RESIDENTIAL BUILDING PERMIT APPLICATION

Street Address: 5240 KALMIA DRIVE Unit:
City: DAYTON State: MD Zip Code: 21036
Subdivision/Village/Complex Name: KALMIA FARMS SDP/WP/BA #:
Lot: 17 Tax Map: Plot 4171 Parcel: Plot 4171 Grading Permit #:

Existing Use: Proposed Use: NEW Detached Garage Estimated Cost: \$ 30,000
Trade Work to Be Completed (Separate Permits Required): Mechanical (HVACR) Electrical Plumbing None
INSTALLING NEW Detached GARAGE PER 84 LUMBER Package. PUTTING ON NEW FLOORS + SLAB. NO UTILITIES AT THIS TIME. GARAGE FOR TRUCKS + LOAD EQUIPMENT.

Subject: Project name Detached Garage 5240 KOLMIA DRIVE Dayton, MD 21036
Project site address 5240 KOLMIA DRIVE Dayton MD 21036
Permit # B20001242 SDP # _____
Other information pertinent to this project REVISED Plot Plan Relocating Garage a Few Feet

BOUNDARY SURVEY
LOT 17, SECTION 1
KALMIA FARMS
PLAT 4171
SITUATED AT #5240 KALMIA DRIVE

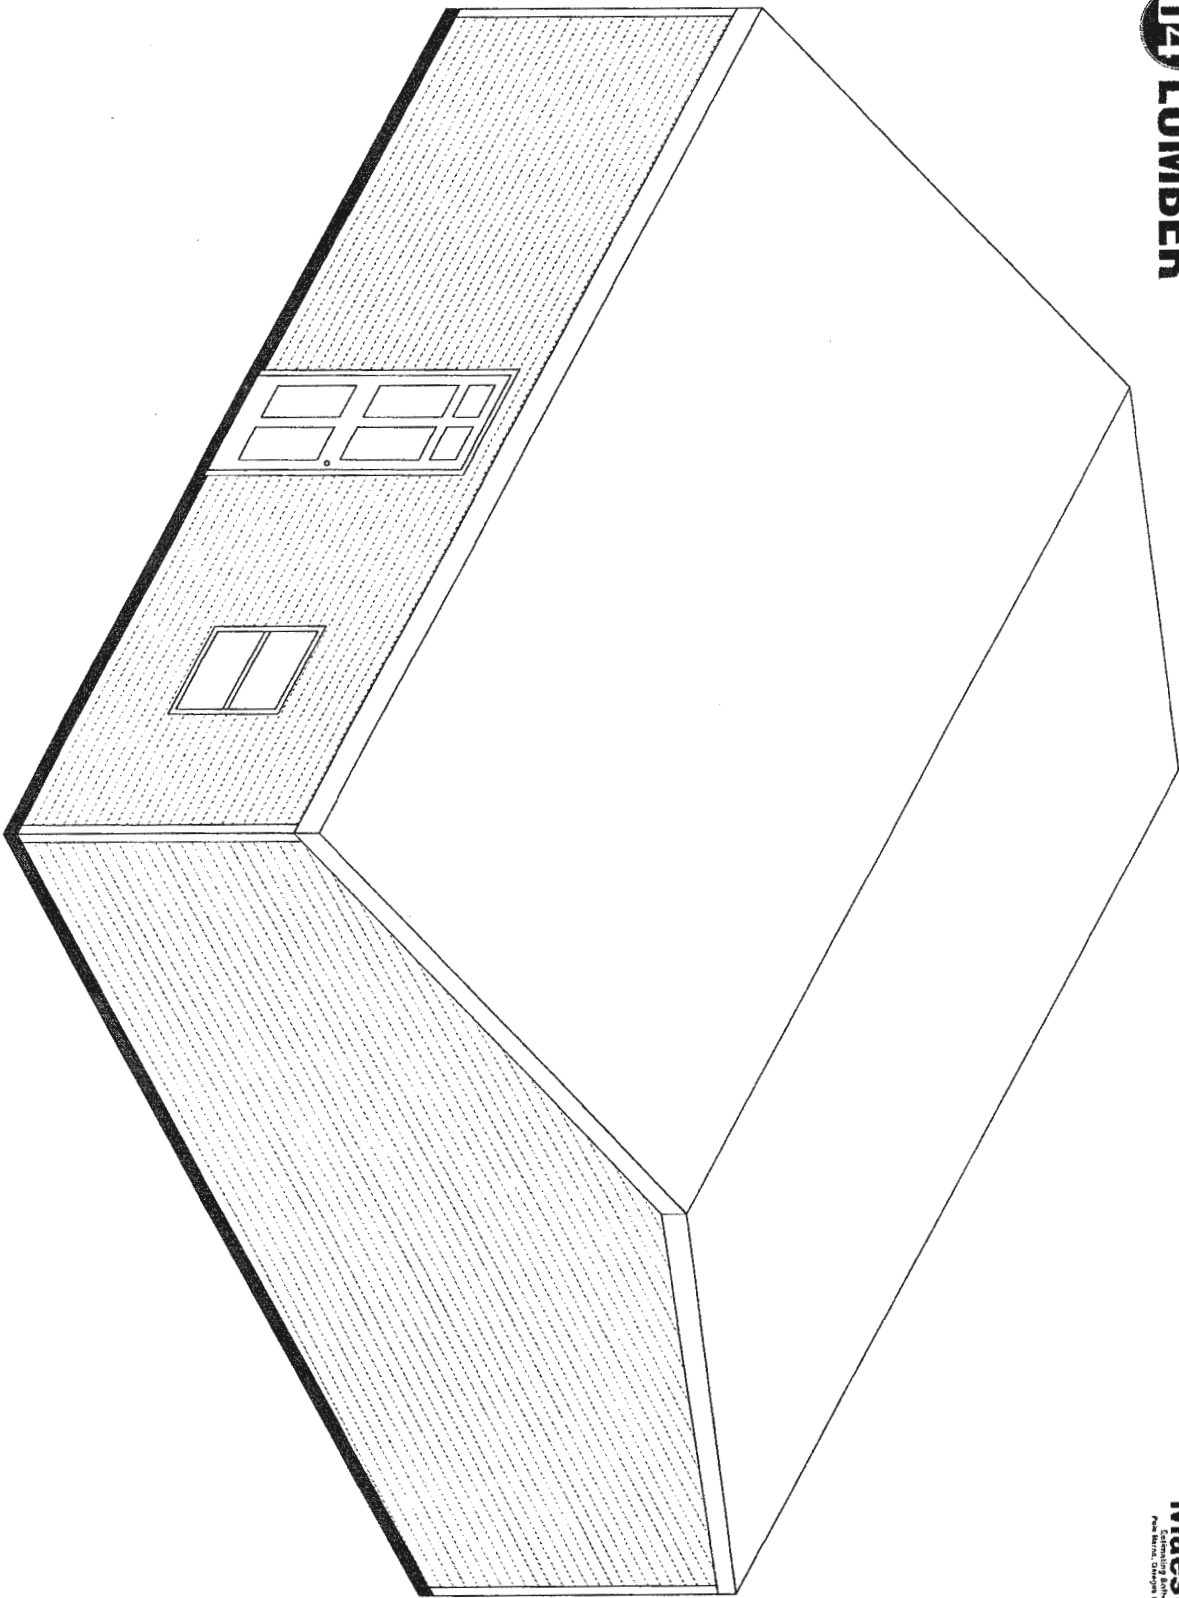
X Other EMAIL - REVISED WELL + SEPTIC SETBACKS

REVISED
Date: 5/15/2020
Comments: B200012A2
PER HEALTH DEPT
